X-TYPE

XT501-S948

TECHNICAL BULLETIN

Front Seat Stabilization Kit –
Change Of Specification –
Service Action S948

ILLUSTRATION 1

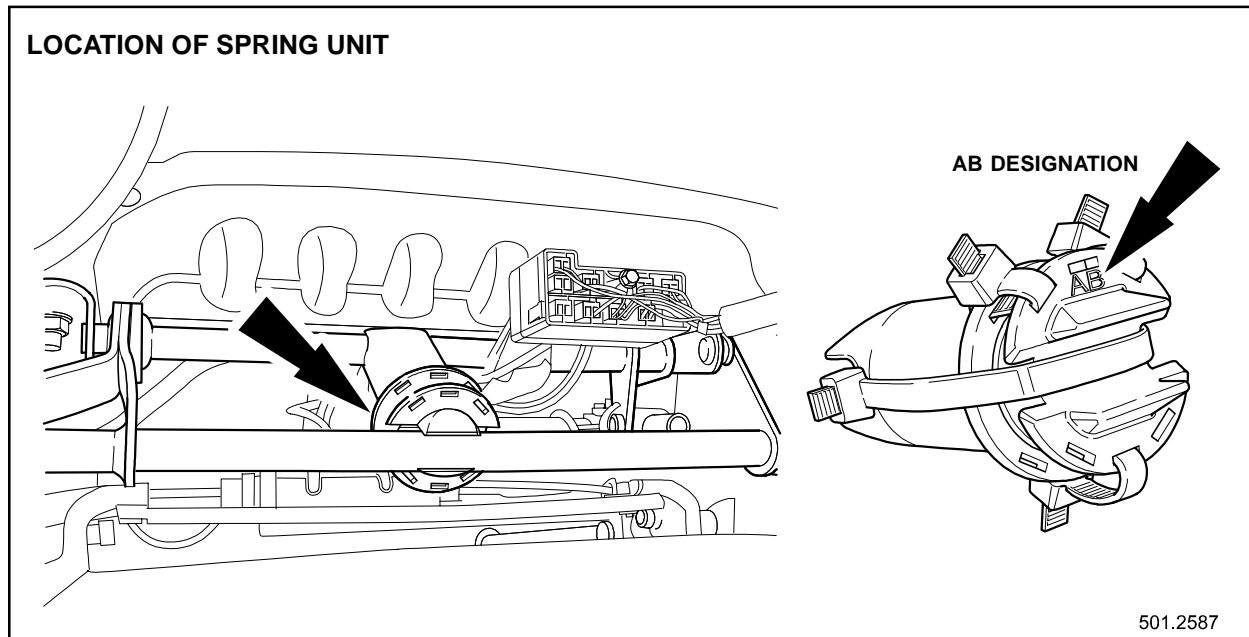
1. Check under seats to confirm the presence of spring unit without 'AB' markings.
See Illustration 1.

ILLUSTRATION 2

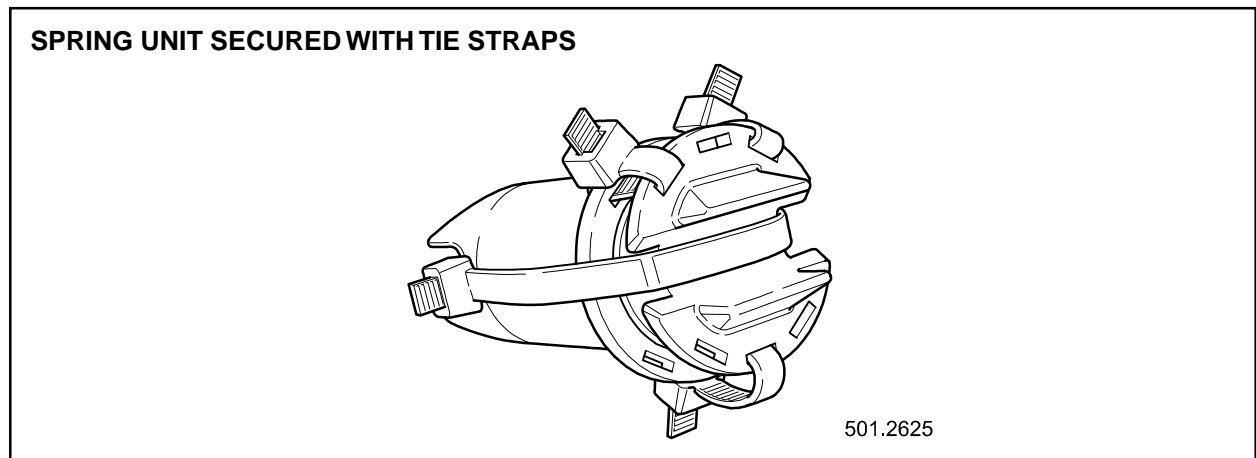
9. Remove spring unit from seat frame front upper and lower cross tubes by twisting 45 degrees sideways.
10. Install remaining black tie strap provided with new parts to center slots on opposite side of spring unit to other two.
11. Install red tie strap provided with new parts around body of spring unit (Illustration 2).
12. Cut, remove and discard protruding tails from the four tie straps.

ILLUSTRATION 3

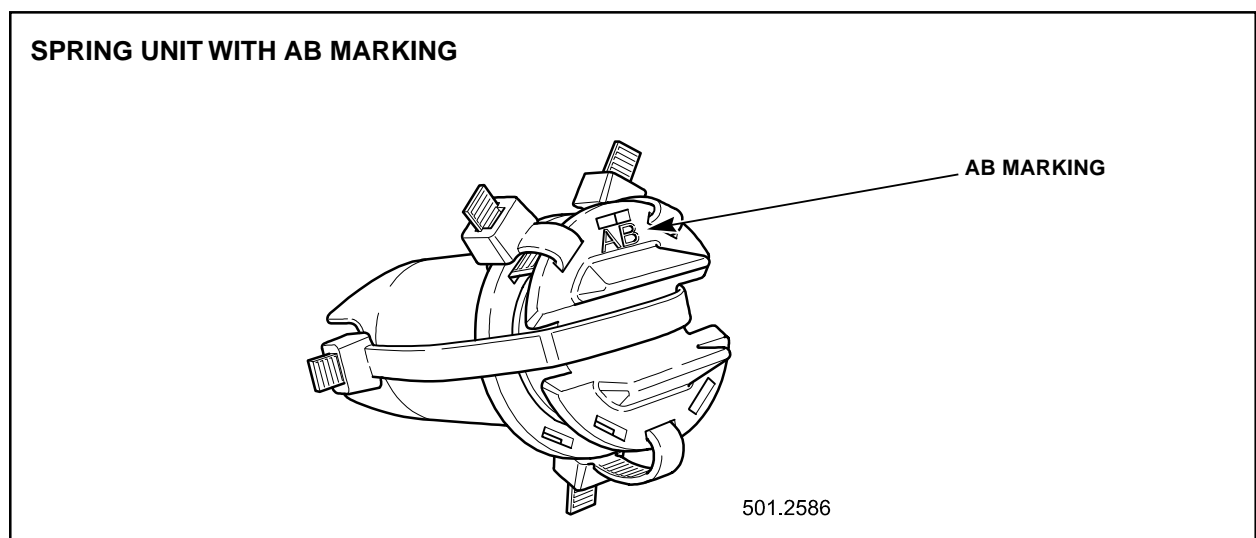
13. Place new spring unit, provided, (with 'AB' marking, see Illustration 3) to front.

ILLUSTRATION 4

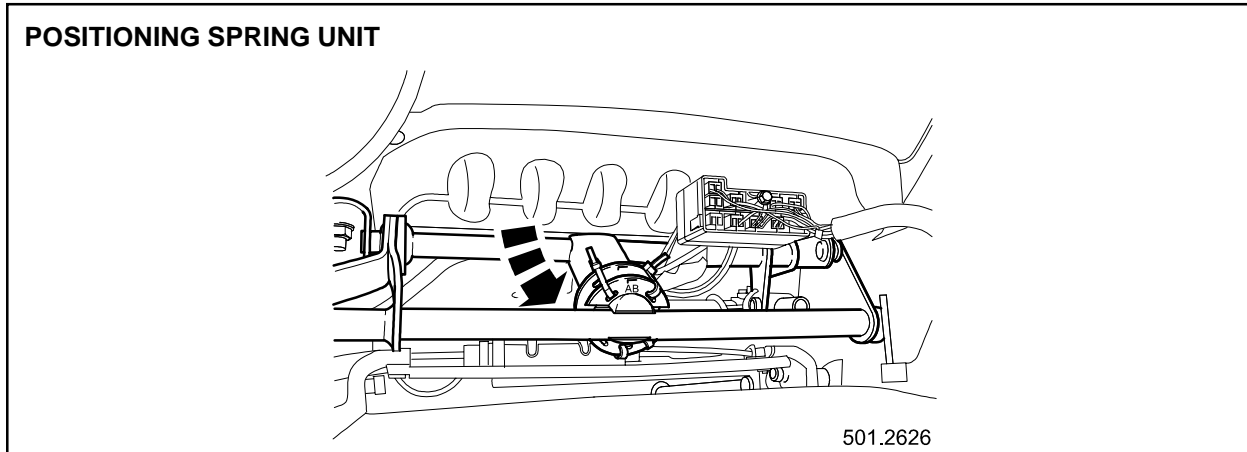
15. Install spring unit to seat frame front upper and lower cross tubes. Spring unit to be inserted at 45 degrees. Engage upper tube first and twist sideways to engage lower tube.

Note: Position the spring unit on the center-line of the seat with two fitted tie straps to the front.

ILLUSTRATION 5

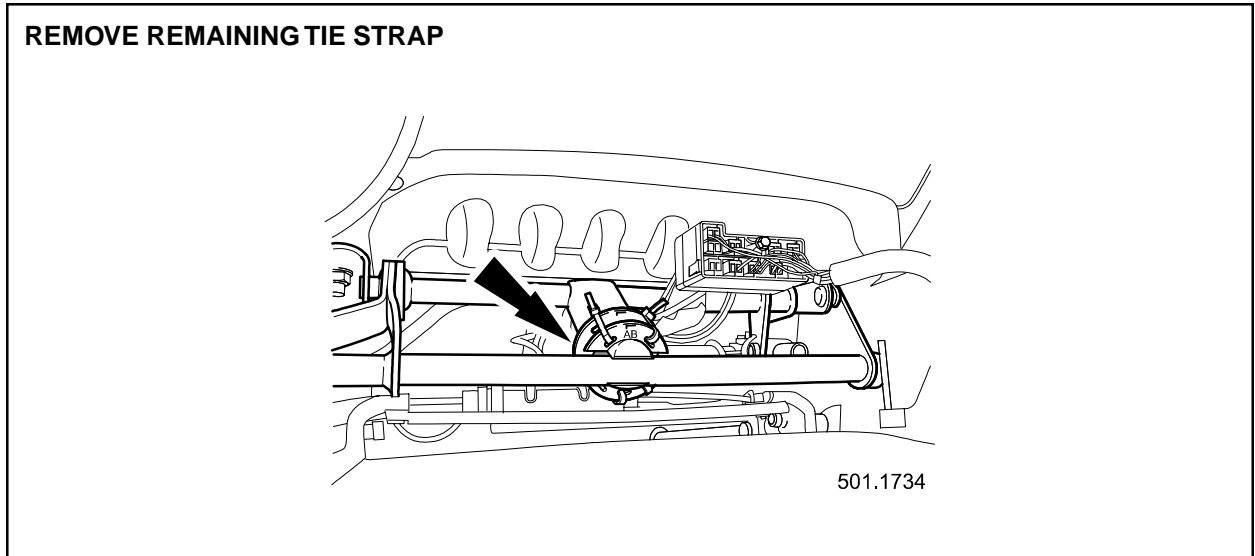
17. Cut, remove and discard the remaining three tie straps from the spring unit (Illustration 5.)
